Technical Note

Project:	P21-184 Littlestone, Kent		
Subject:	Technical Note – LLFA Response to Overland Flow Routing (Received 6 May 2022)		
Prepared by:	Lance Hammond – Project Engineer	Date:	24 May 2022
Authorised by:	Nick Fenton – Associate	Status:	S2 - Information
Document Ref:	0058-RLL-00-XX-TN-C-003	Revision:	P02

This Technical Note has been prepared by Rodgers Leask in response to the LLFA consultation response received on 6th May 2022 reference: FHDC/2021/085984.

OVERLAND FLOW ROUTING

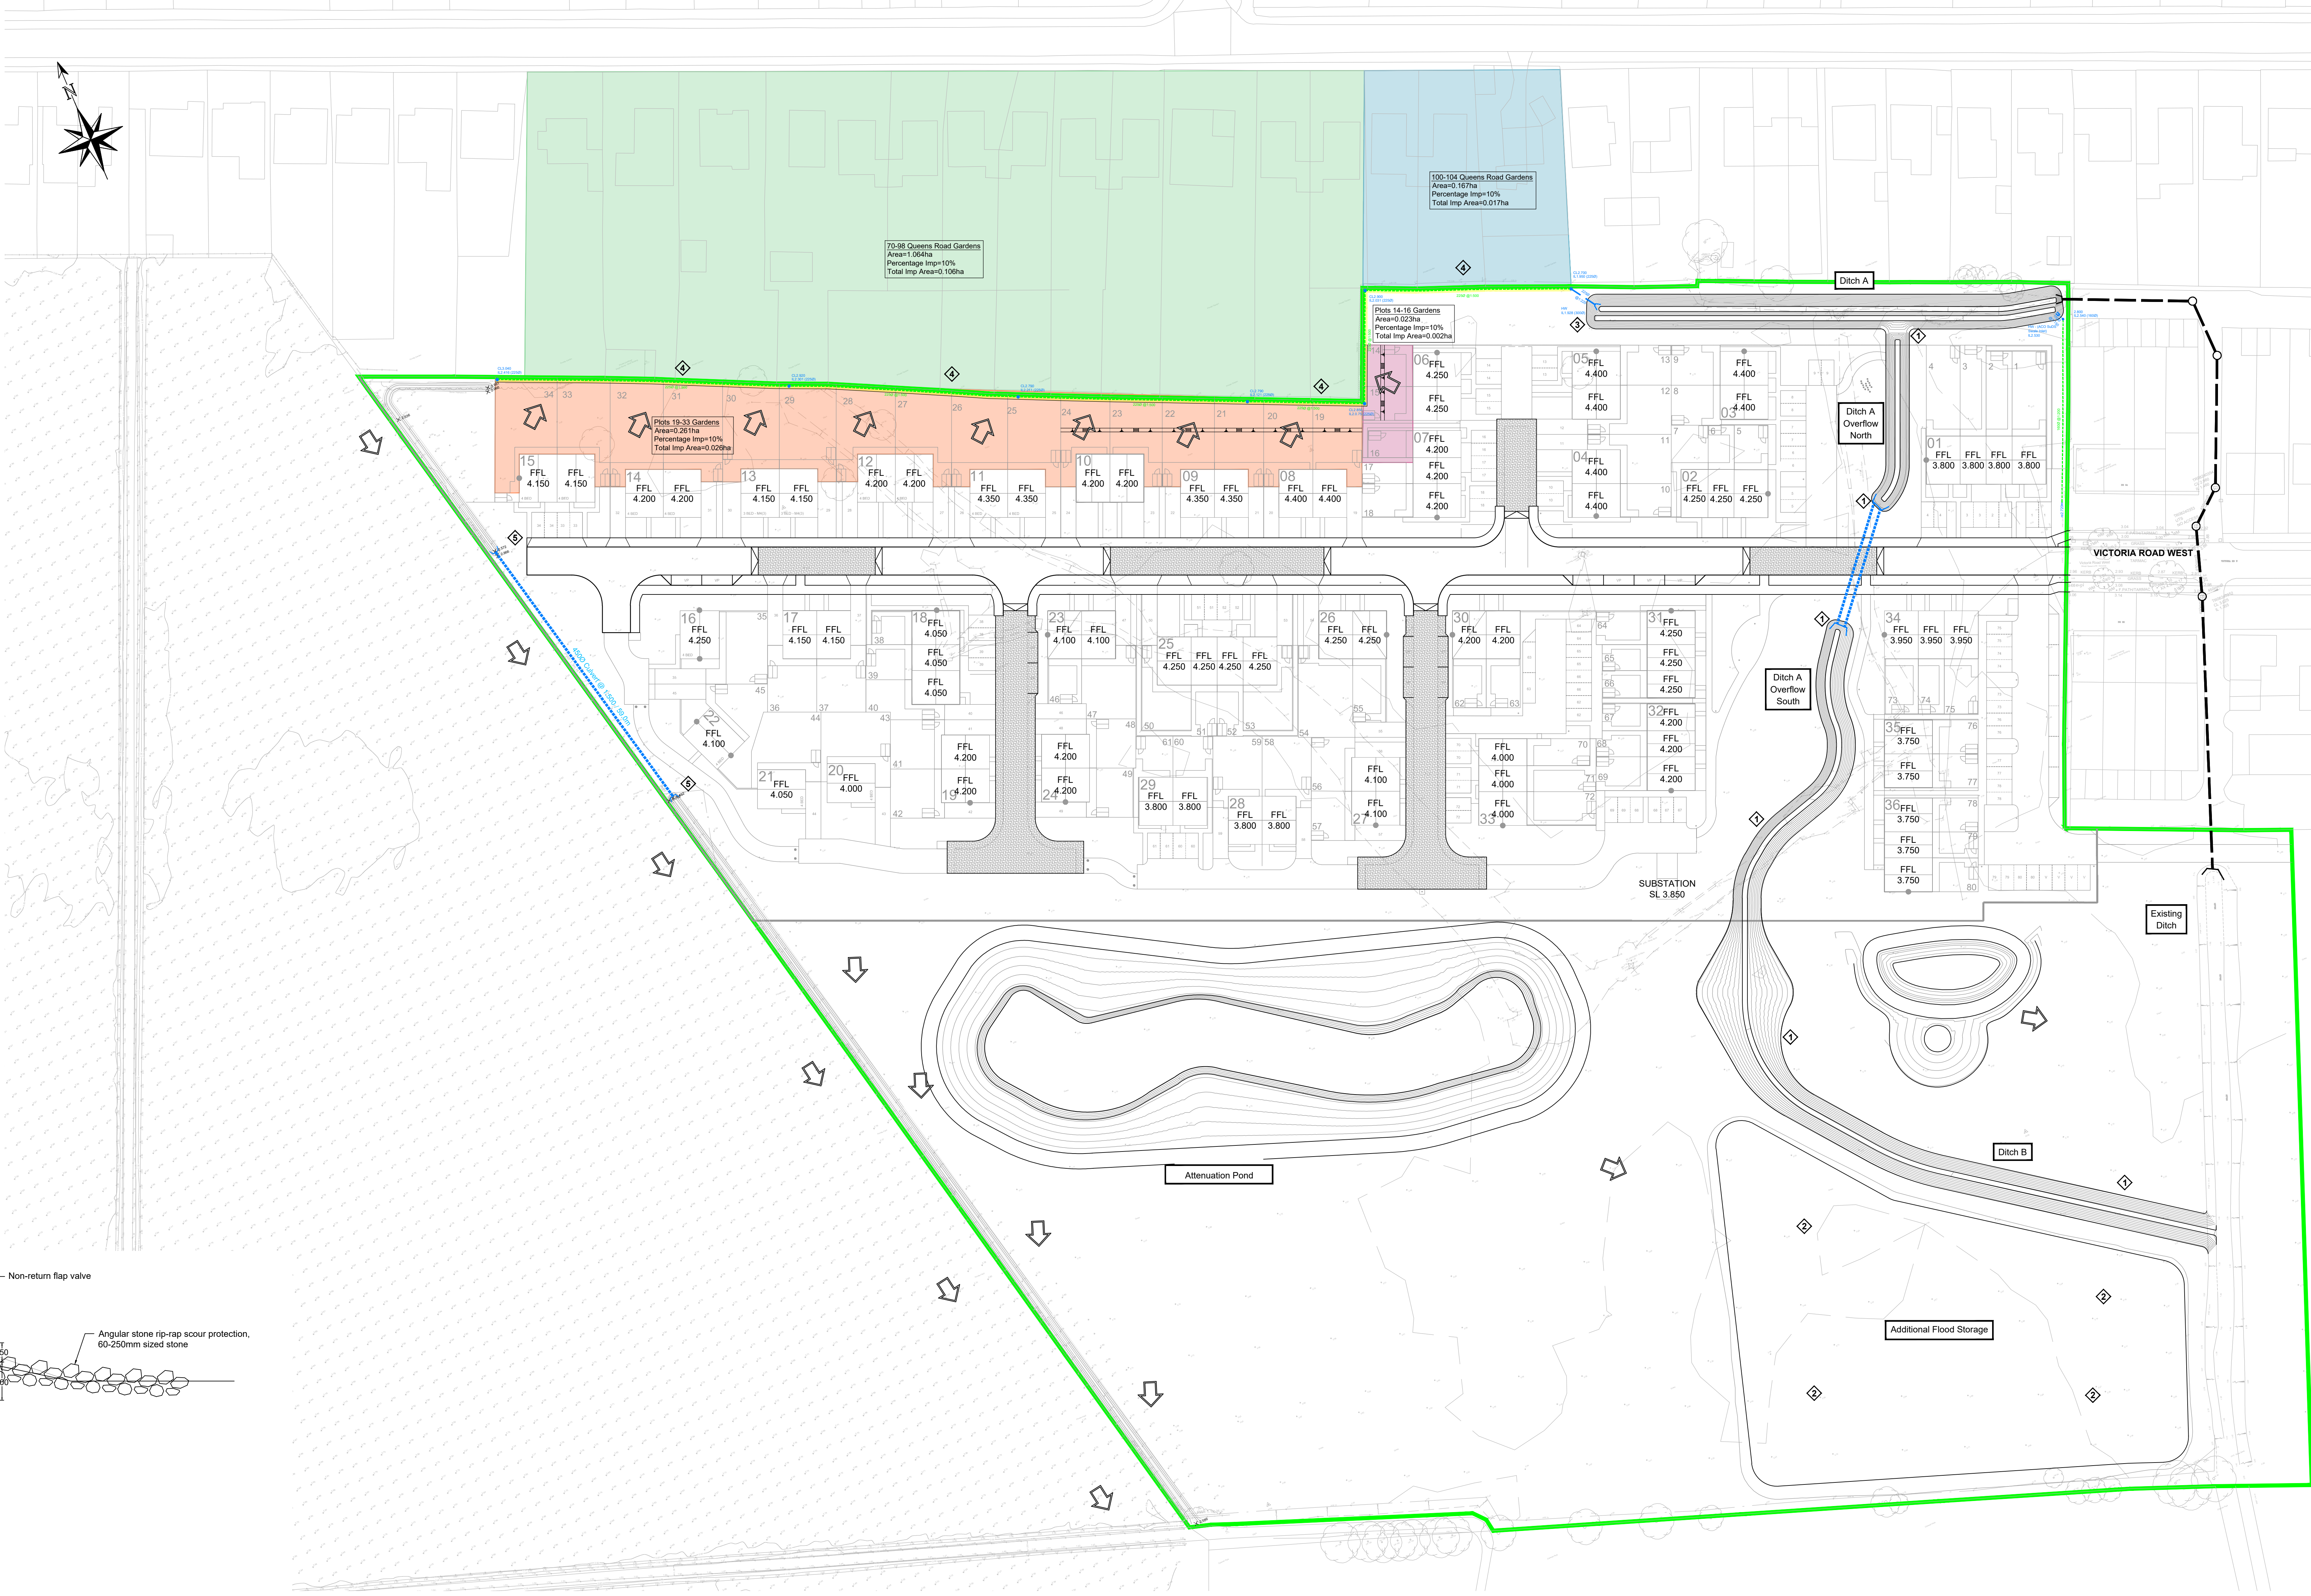
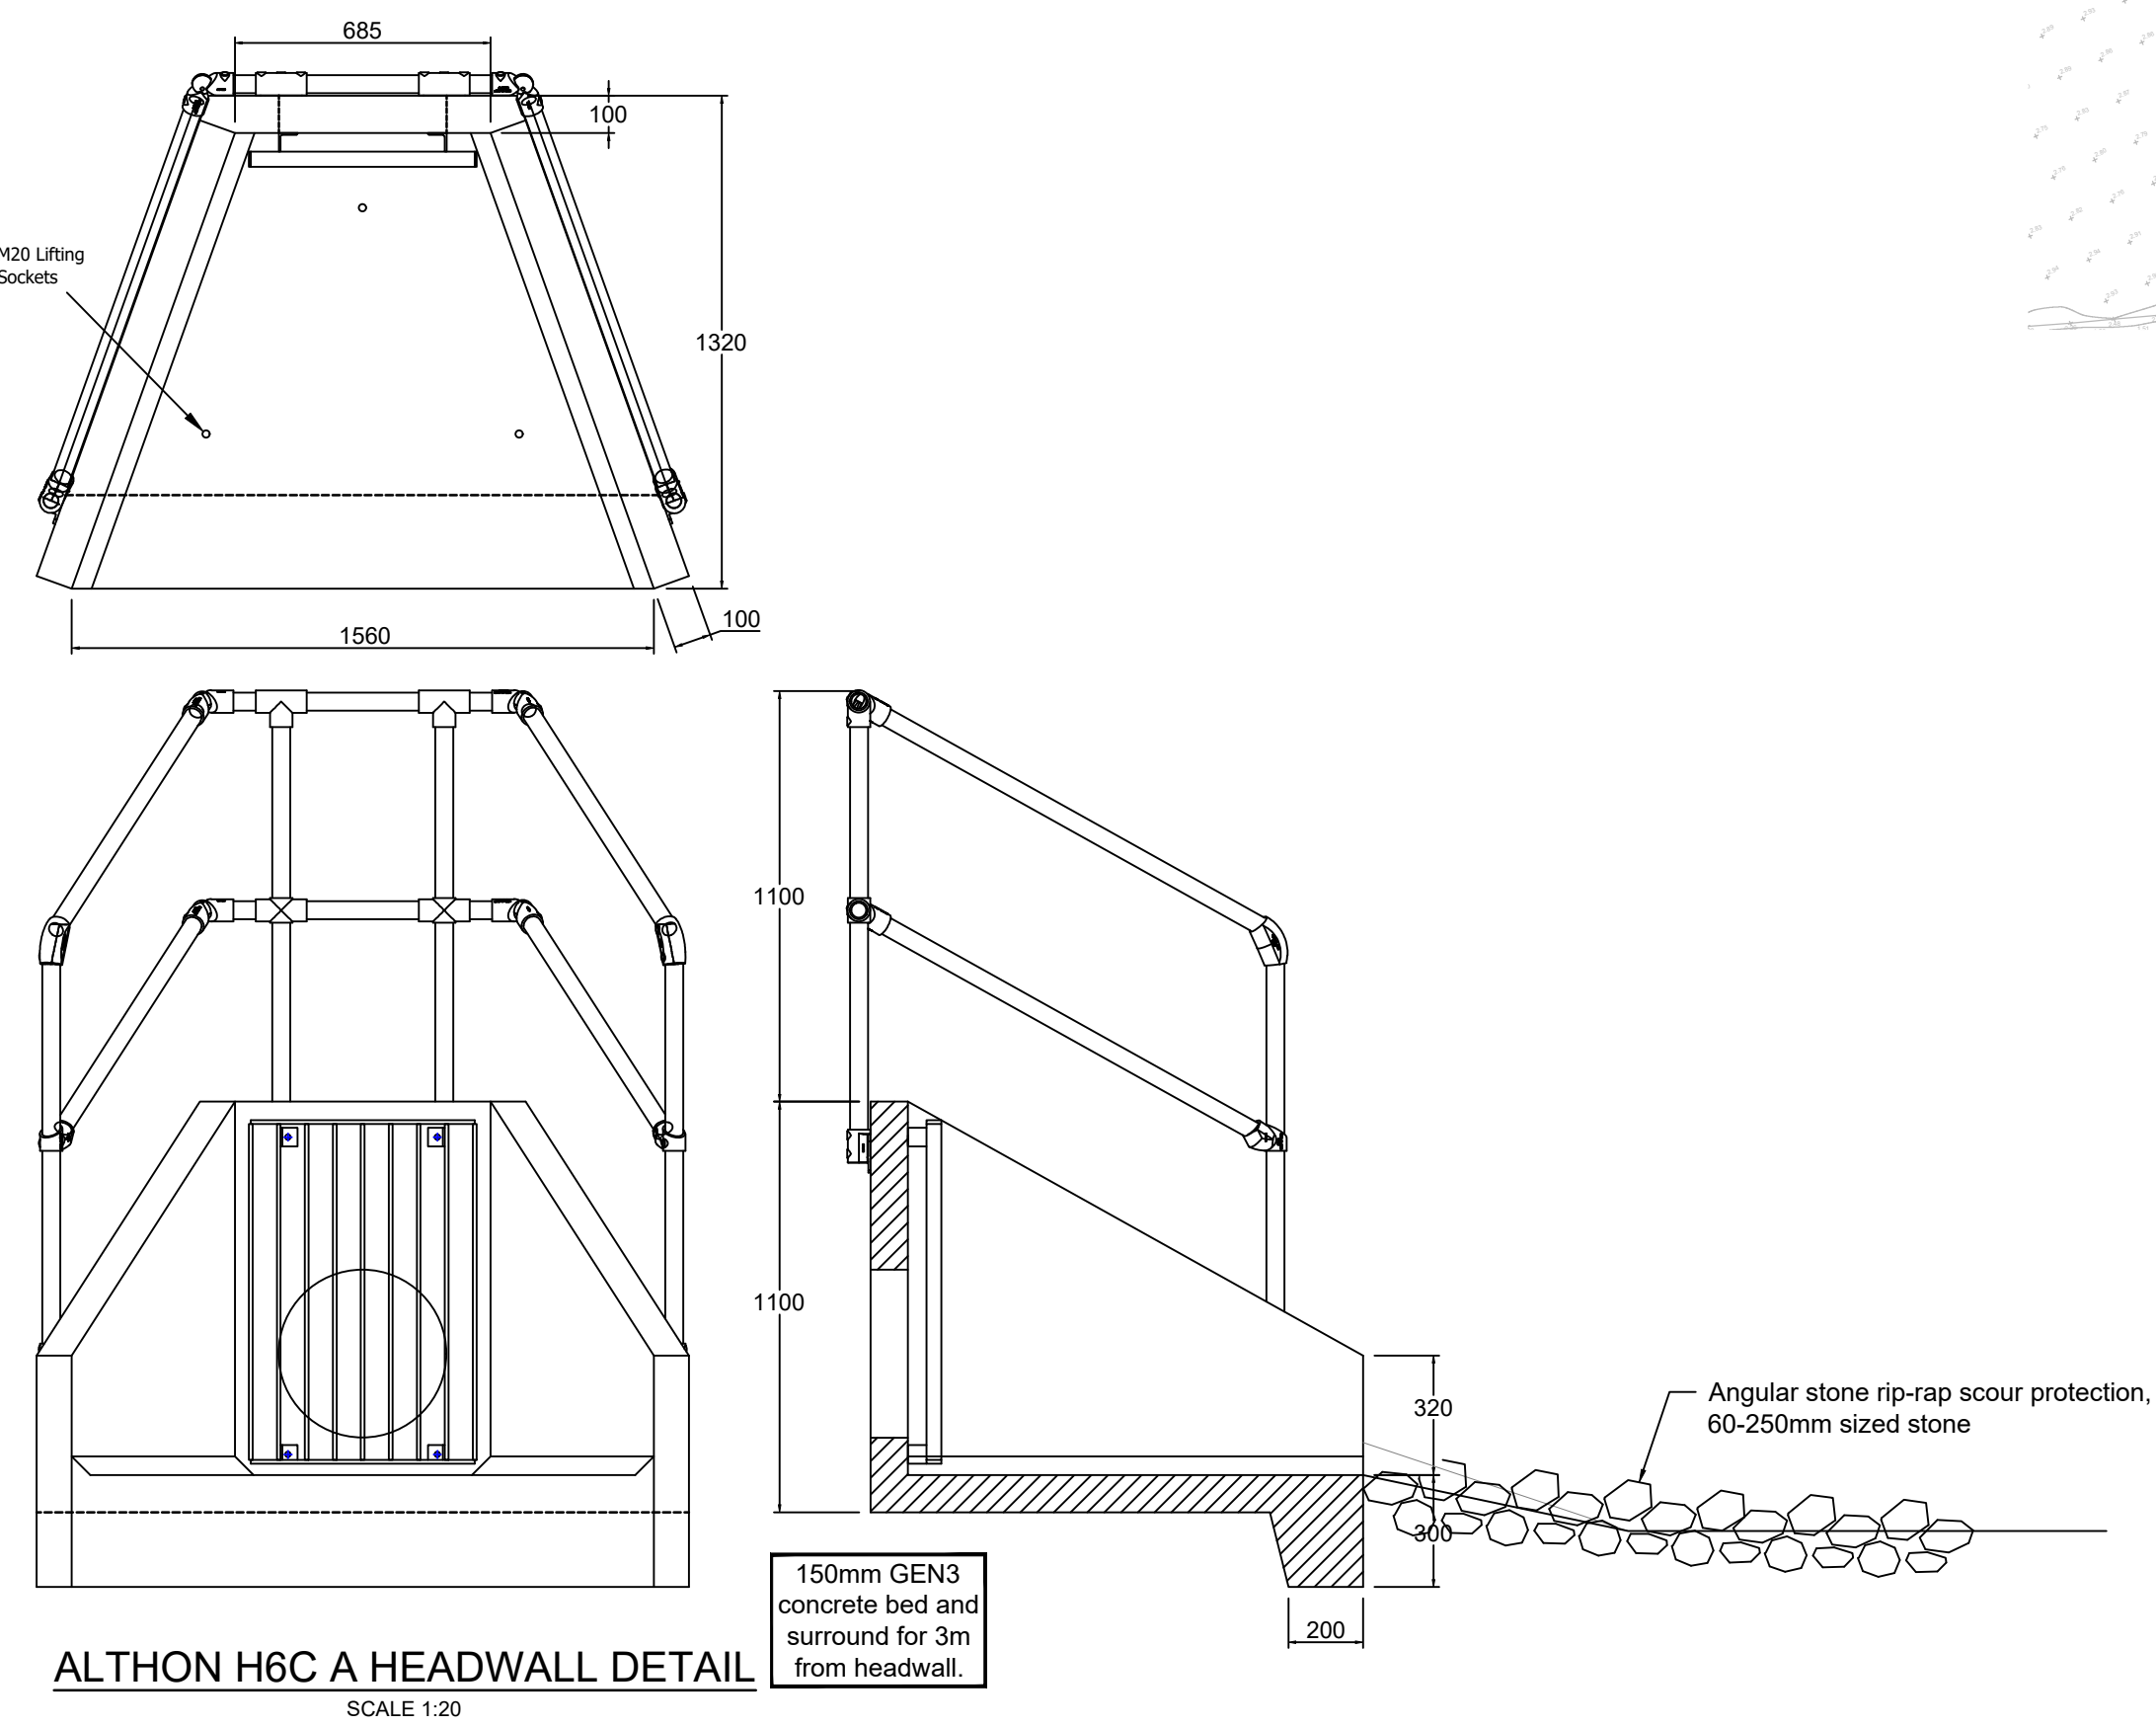
In addition to the ditch on the western side of the site, a further proposal is made regarding the possible runoff from the rear of the properties along Victoria Road and the draining of the land at this location. A 175mm perforated land drain would be installed along the northern boundary within the rear gardens of the new properties. This drain would convey any surface water into Ditch A and then be conveyed southwards.

Whilst an approach such as this is welcomed, it would be our preference for a larger gravel filled trench (minimum 300mm and inclusion of a perforated pipe) to be utilised instead. This is to improve upon overall interception and capacity of the feature. Consideration should also be applied to undertaking a catchment assessment to determine the relative contributions that would occur (overland flows), and the actual size of the trench/ drain required.

The LLFA view that any future feature positioned within these rear gardens should be managed in perpetuity. This is to protect both the existing properties along the southern side of Victoria Road and the new dwellings, to ensure appropriate land drainage. The creation of this feature also develops concern around access, infill/ removal and maintenance of the feature long term. One option for future consideration is the implementation of a restrictive covenant.

Overland Flow Routing drawing 0058-RLL-00-XX-DR-C-1015 has been updated to refine the position of the proposed land drain. The proposed land drain has been detailed to show a 225mm diameter perforated pipe within a 600mm width gravel filled trench to improve interception and capacity as requested. Modelling of overland flow from existing gardens to the rear of properties in Queens Road and rear gardens from the proposed development has been undertaken to size the land drain.

The fencing to the rear of the proposed gardens has been offset 1m to provide an access for maintenance of the feature in perpetuity. Maintenance will be undertaken by a private management company.
